## Urgent Field Safety Notice

### Single Chamber Temporary External Pacemaker 53401

Medtronic reference: FA824

**FIGURE 1- updated firmware displayed in this image**

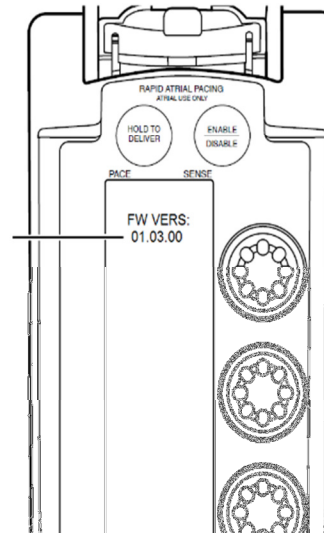
1. Verify whether 53401 EPGs in your possession are affected.
2. If your EPG is affected, complete the following:
  - Determine if the EPG firmware has been updated.
    - Power unit on and view firmware version (Figure 1 below).
    - If firmware version is 01.03.00 or greater, EPG firmware has been updated with correction for this issue. No other action is recommended.
    - If firmware version is 01.02.00, EPG firmware has not been updated. You may arrange to have your Medtronic Service Center update the EPG firmware at no charge.

During power up process, Firmware Version will be displayed for 2 seconds

Recently, Medtronic received approval for a firmware correction that prevents occurrence of this issue. Medtronic recommends customers send affected devices to Medtronic Service to update the firmware to prevent this issue.
